414-S840

Dead Battery – Excessive Quiescent Drain
With Auto Headlamp System On –
Service Action S840

MODEL 2003 MY
XK Range
VIN A30645-A35304

ILLUSTRATION 1

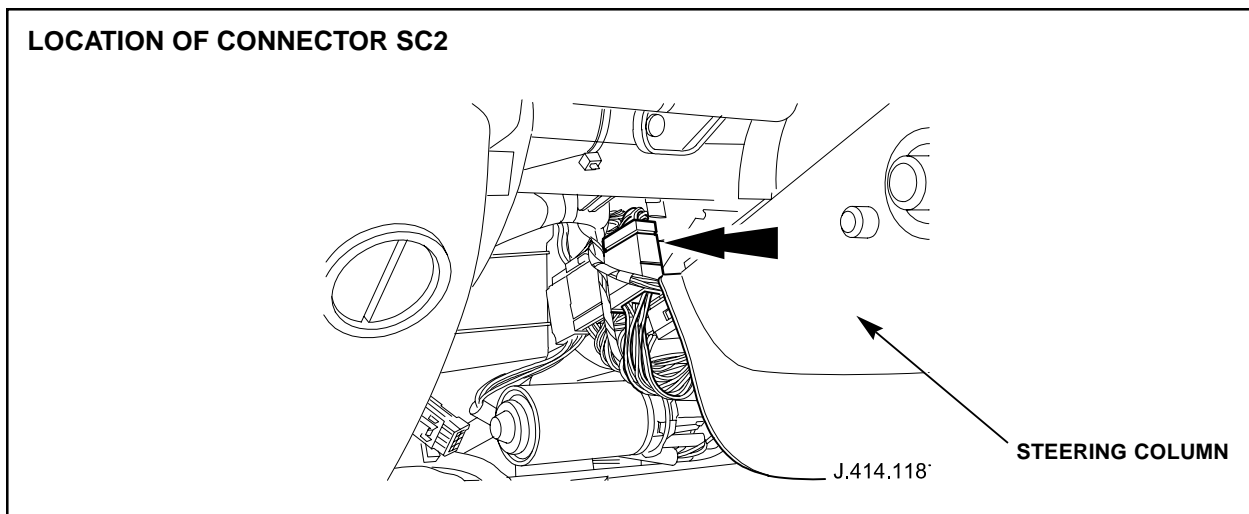
4. Disconnect the column lighting stalk switch connector SC2 (yellow 10-way). Illustration 1).
5. Unlatch and open the anti-back-out device on connector SC2.

ILLUSTRATION 2

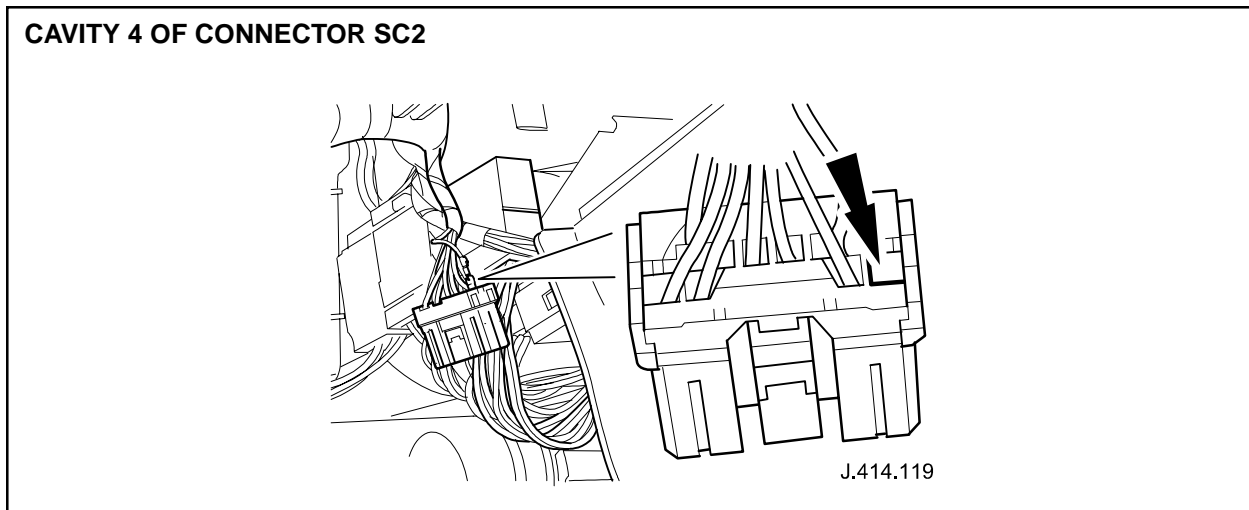
6. Back out terminal (blue/yellow wire) from connector SC2 cavity 4. Illustration 2. Refer to Figure 0.2 of the 2003 MY XK Electrical Guide.

Note: Take care not to disconnect the terminal (yellow/blue wire) from connector SC2 cavity 1.

ILLUSTRATION 3

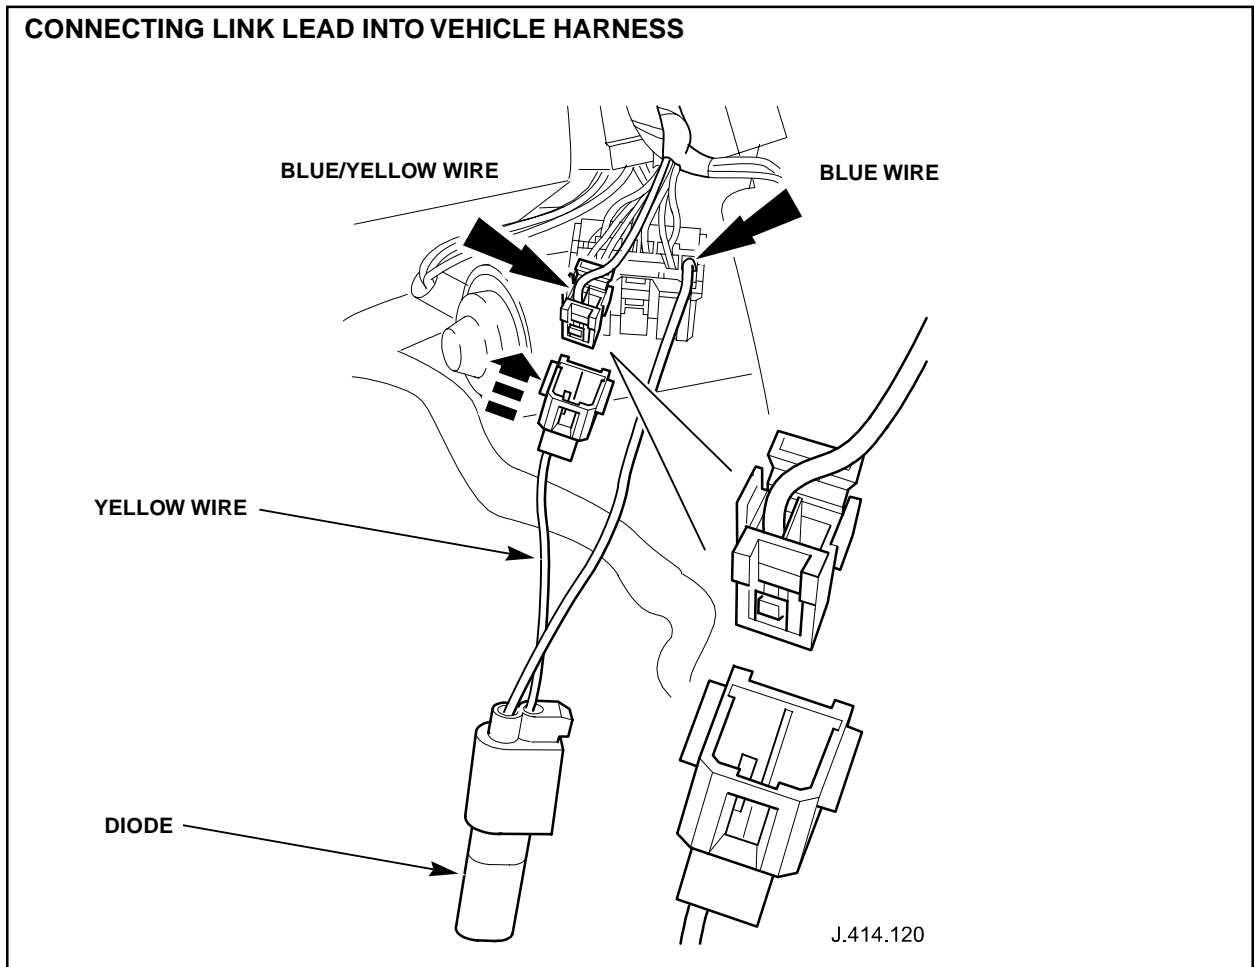
8. Insert the disconnected terminal (blue/yellow wire) into the cavity of the new connector.
Illustration 3.

9. Close and latch the two-way connector anti-back-out device.
10. Connect the new diode assembly fly-lead (yellow wire) to the new two-way connector.
Illustration 3.

11. Insert the terminal (blue wire) from the new diode assembly into connector SC2 cavity 4.
Illustration 3.
12. Close and latch connector SC2 anti-back-out device.
13. Connect the lighting stalk column switch connector SC2 (yellow 10-way).

ILLUSTRATION 4

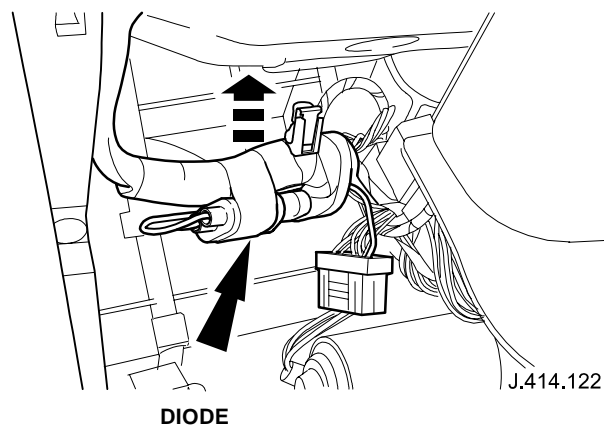
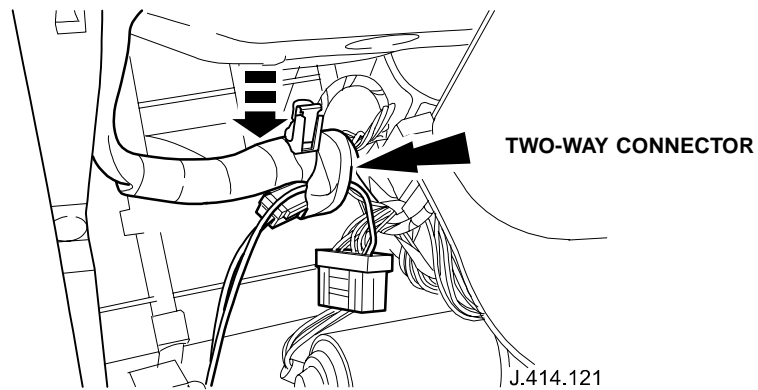
14. Using a suitable adhesive tape, position and secure the two-way connector and diode assembly (Illustration 4).
15. Refit the dash liner.
16. Reconnect the battery, see Workshop Manual, JTIS, CD ROM, section: 414-01.
17. Remove the vehicle protection kit.
18. Close the luggage compartment and the door.
